## Remarks

For: ROBOT DEVICE

REQUEST TO APPROVE DRAWING CHANGES

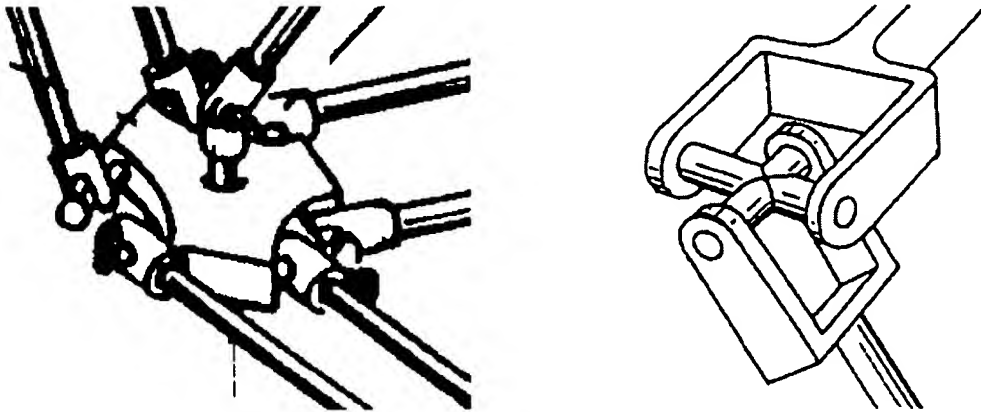
Clavel does not suggest the ball and socket joint according to the present invention. Below are reproduced the joints suggested by Clavel. As can be seen in both of these views, Clavel suggests cardan joints, which are multi-element linkages. Clavel describes these joints as col. 4, lines 13-17. Cardan joints are couplings using a double yoke and four-point center cross.

Cardan joints are used as couplings in the driveshafts of rear-wheel drive cars, but can produce uneven shaft speeds when operated at joint angles of more than a few degrees. Cardan joints include many moving parts that result in inherent high friction and complexity in changing any parts. Such a joint does not suggest the ball and socket joint of the present invention.

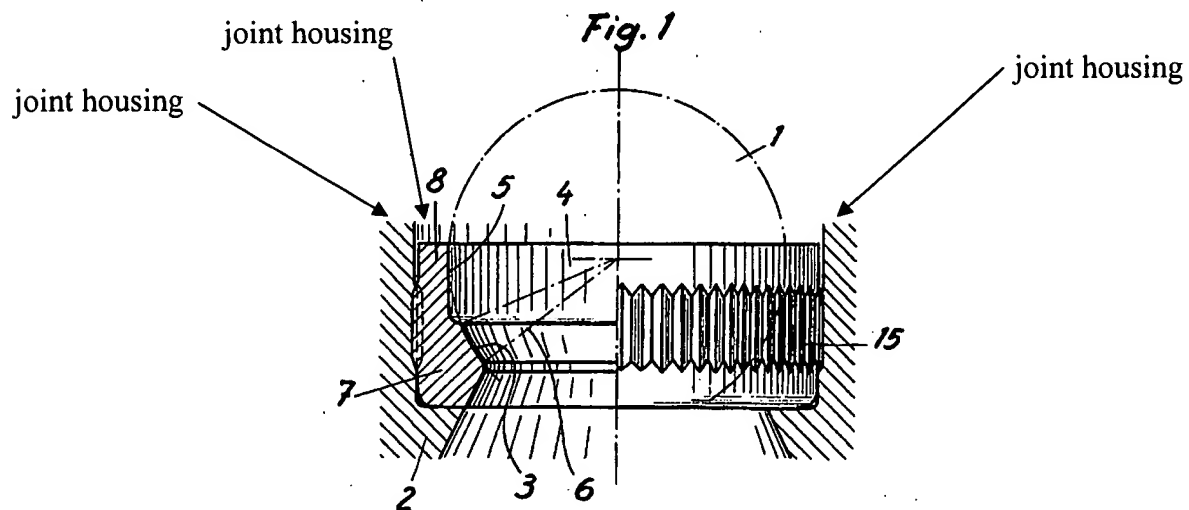
Latzen suggests joints that virtually completely envelop the ball. One example of such a joint is shown in Fig. 1, which is reproduced below. It is important to recognize that Fig. 1 and the other figures illustrate cut-away views of the joints, as indicated in by the arrows in Fig. 1 as reproduced below, and that the joint housing 2 extends about the entire ball head. Fig. 2 illustrates a similar view and Figs. 3 and 4 illustrate a non-cut away views of the housing almost entirely surrounding the ball.

Such joint housing that surrounds more than approximately one-half of the joint ball is contrary to the present invention as recited in the claims. Including such joints in a robot according to the present invention would severely limit the operation of the robot for a number of reasons. The joints suggested by Latzen would have much higher friction and simply physically limit the movement of the ball and socket relative to each other. Additionally, it would not be remotely easy to replace the bearing member of the joint suggested by Latzen as is possible to replace the bearing member according to the present invention.
